# Attachment A: Issue No 1 - Adequacy of view assessment

# Attachment B: Issue No. 2 - Built form massing

# Attachment C: Issue No. 3 - Podium facade design quality

### Demonstration of existing view from Hotel window and actual view loss (3/3)

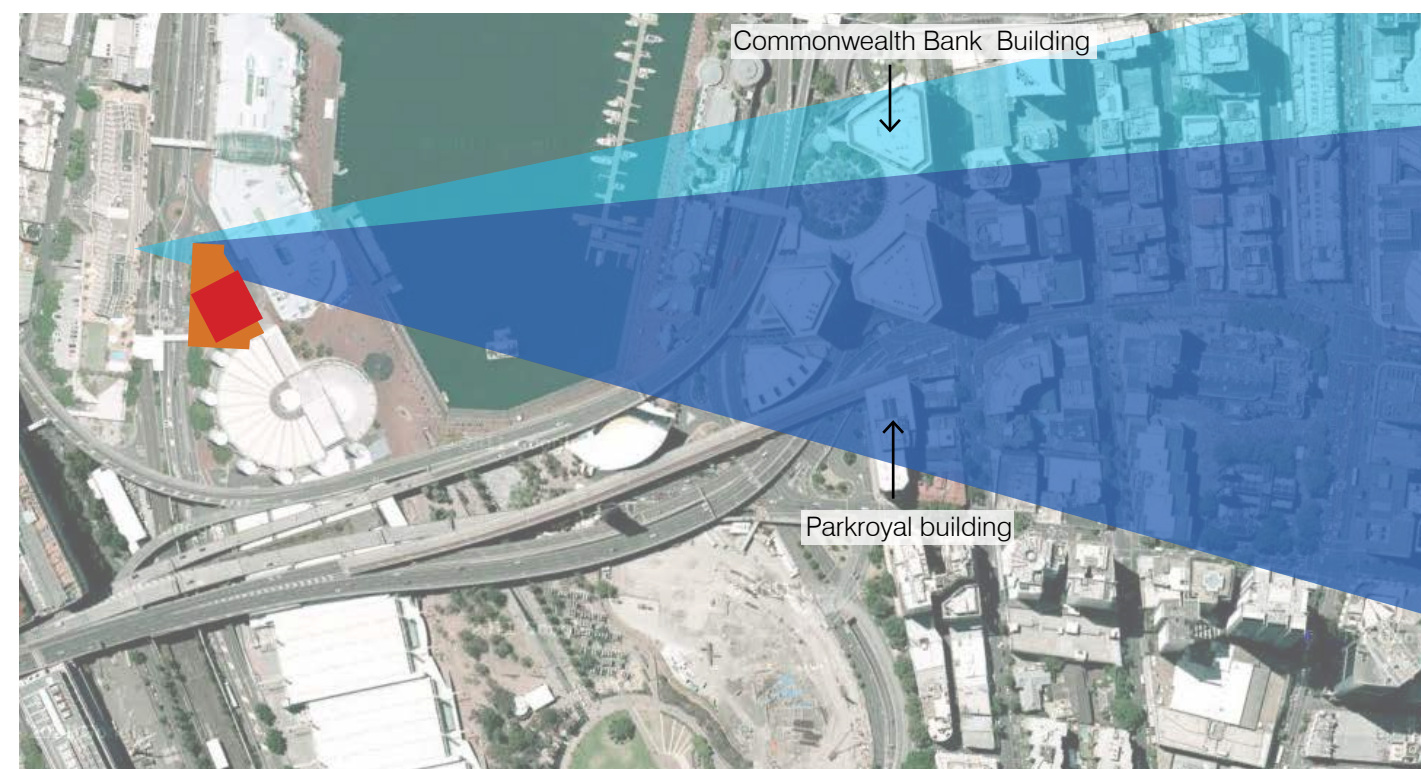
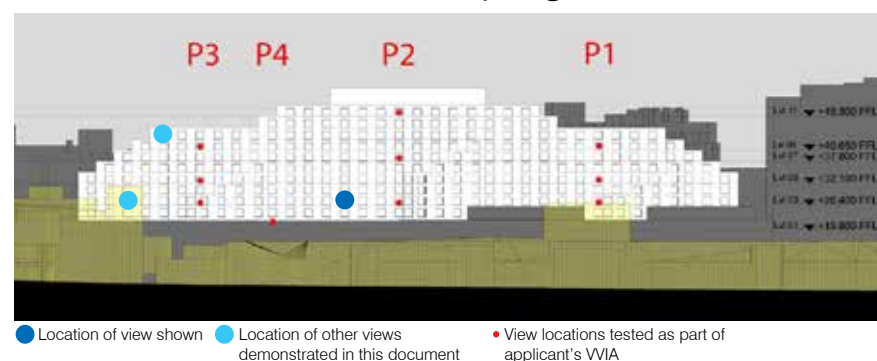
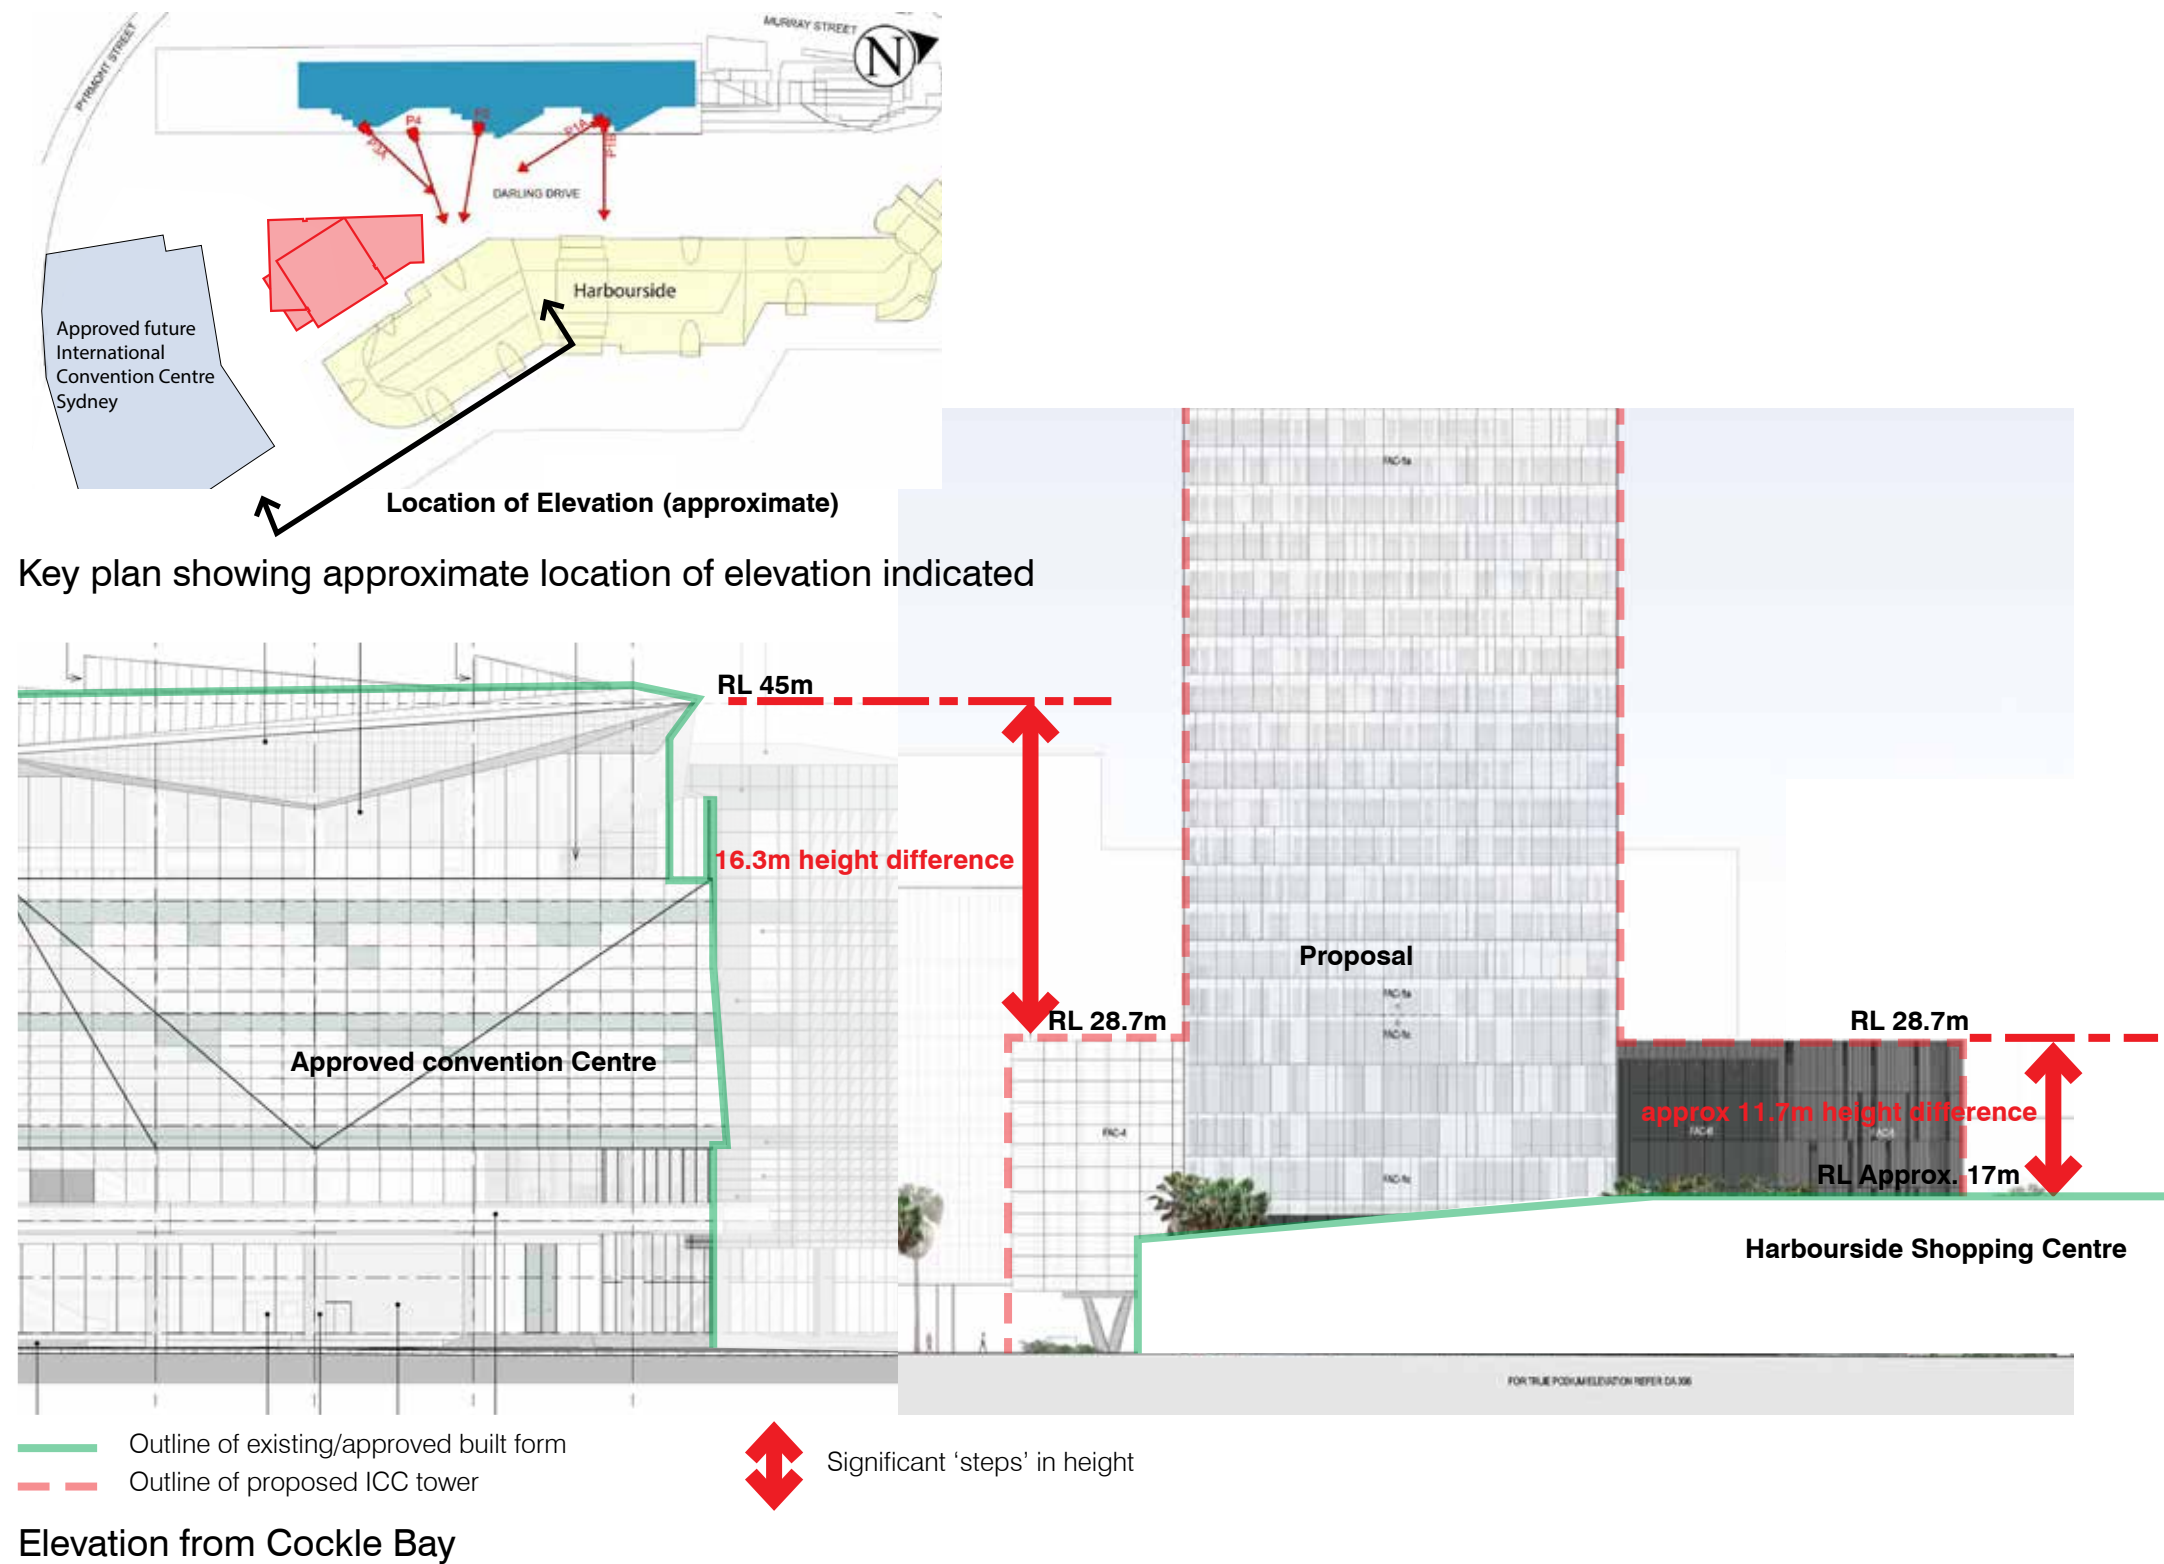
This plan shows the approximate impact of the proposal on the existing view shown to the left.

The existing view demonstrated from this room will experience:

- An approximately **80% obstruction** to the existing cone across the horizon line.
- A **loss of the majority of the key focal area** of the view - the waterfront and in particular the southern end of Cockle Bay.
- Replacing the existing view will be a **sheer wall with minimal articulation** (see Attachment C).

## Currently proposed podium massing - relationship with Darling Drive

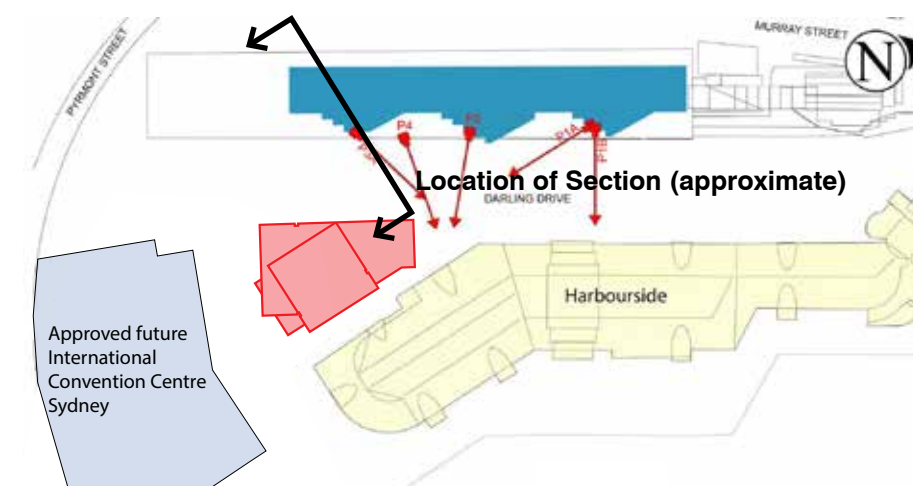
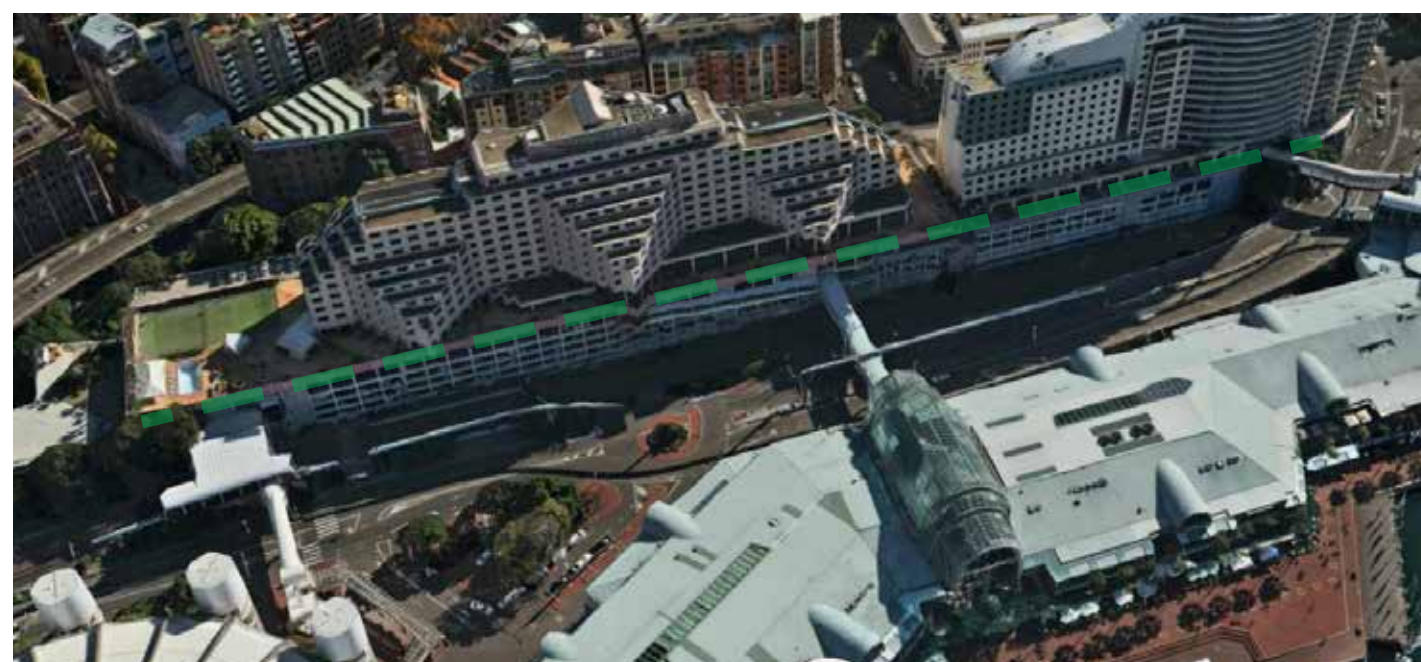
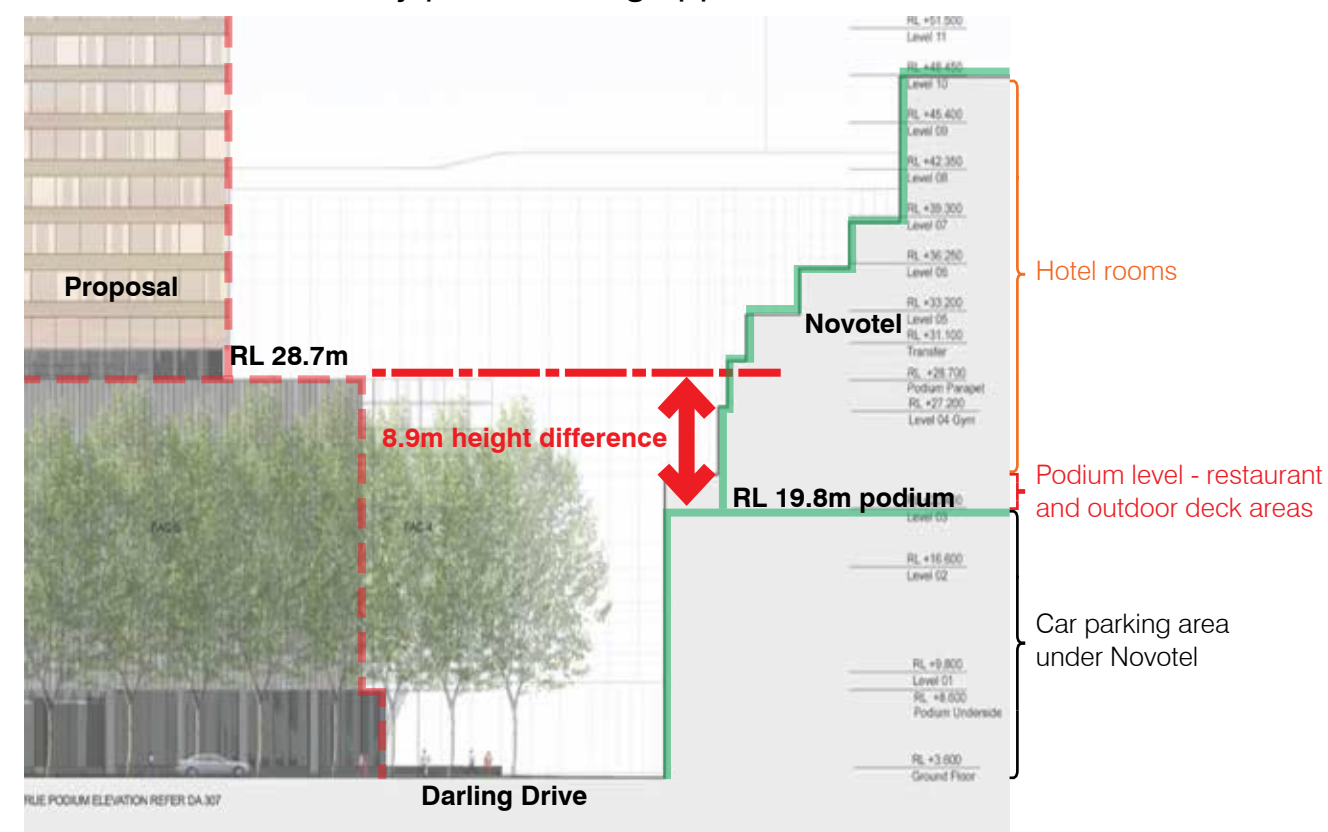
The proposal's podium:

- **Does not relate** to the existing, established podium heights along Darling Drive, including that of the Novotel, directly opposite.
- Presents an excessive bulk to the streetscape.
- As a result, the lower-floors of the Novotel, including the outdoor 'deck' areas and restaurant (one of the most active parts of the Novotel) will **directly face the rear facade** of the podium.

### Recommendation: Potential alternative podium form

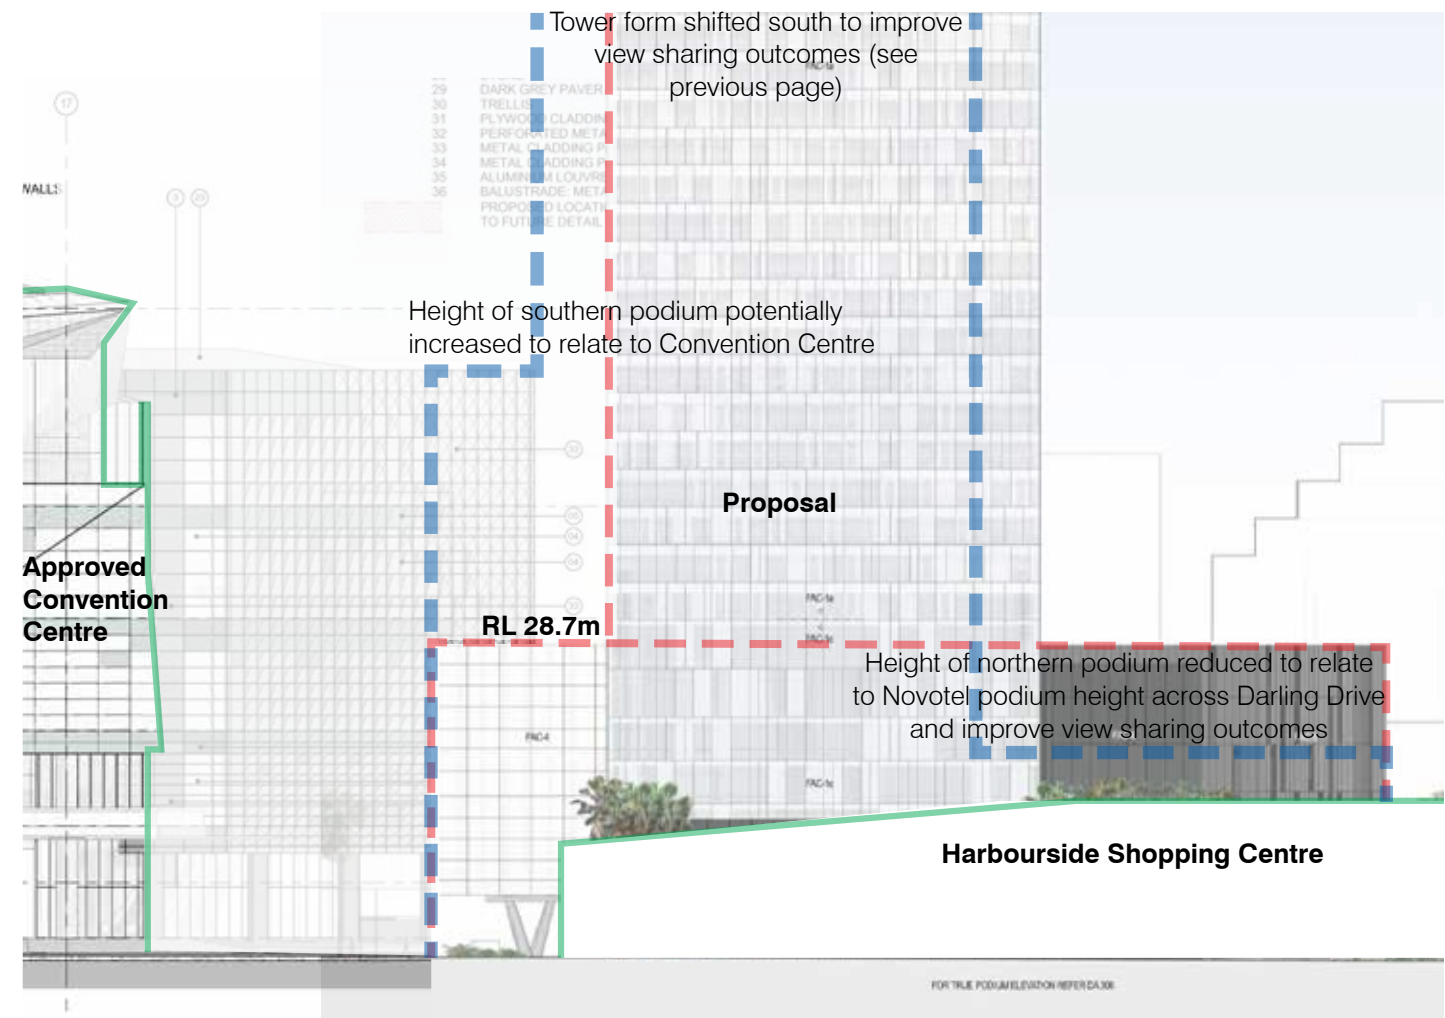
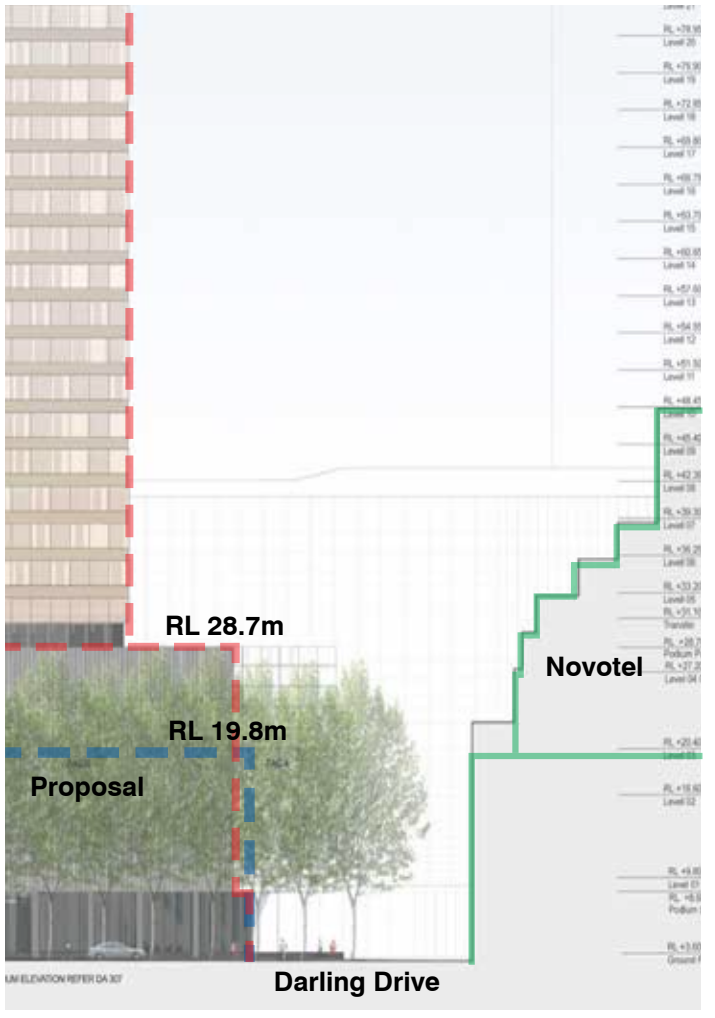
The podium form has not been designed to minimise its visual impact, to provide good streetscape outcomes or massing relationships to adjacent buildings.

It is suggested that consideration should be given to reducing the podium height to match that of the Novotel across Darling Drive. This would:

- Significantly **improve visual impact outcomes** for the Novotel podium (including restaurant, reception and public areas).
- Reduce the visual bulk of the podium.
- Provide **improved streetscape outcomes**, relating to the existing strongly defined podium height along Darling Drive.

After reducing this podium height, in order to provide a similar development capacity, the following options could be considered:

- Relocating plant rooms to basement levels.
- Providing a height increase to the south of the existing podium, where visual impact is lesser and an increased podium height would provide a relationship to the approved Convention Centre.
